**WISDOM
INDUSTRIES, Ltd.**

SAFETY BULLETIN

DATE: FEBRUARY 6, 2006
RIDE: SIZZLER
SUBJECT: SIZZLER LAPBAR MODIFICATION
COMPLIANCE TIME: IMMEDIATE

**RE: INSTALL A SPREADER TUBE & STEP PLATE
IN THE LAPBAR.**

WISDOM INDUSTRIES Merino, CO 80741	APPROVED BY:		
	DESCRIPTION: HANDLE BAR MODIFICATION	SCALE:	NTS
DRAWN BY: SIZZLER	DATE:	JAN 8 - 06	
	DRAWN BY: M. HOPMAN	DRAWING NUMBER:	FB MOD

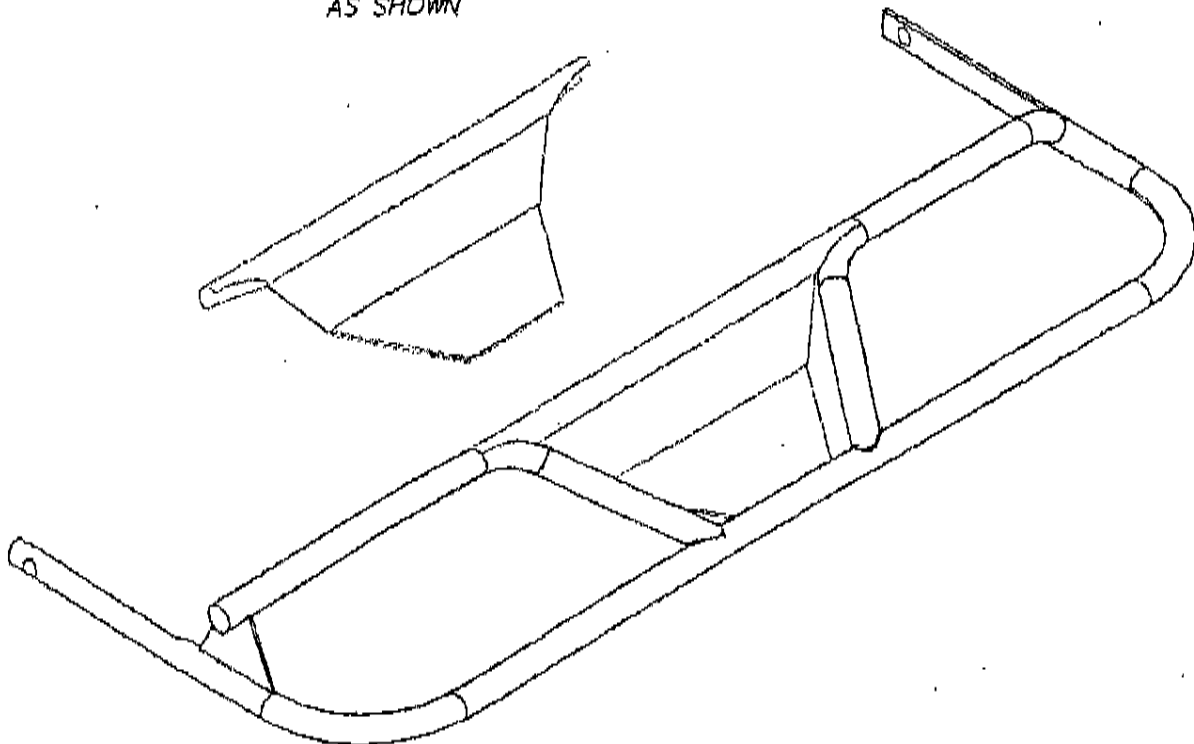
1. Install angle cut tube across lapbar.
2. Trim tube to fit between bent tubes.
3. Weld tube to bent tubes.
4. Weld step plate in center of lapbar opening.
5. Prime and paint tube & plate.
6. Repeat for each lapbar.

WELD IN TUBE AND STEP PLATE
AS SHOWN
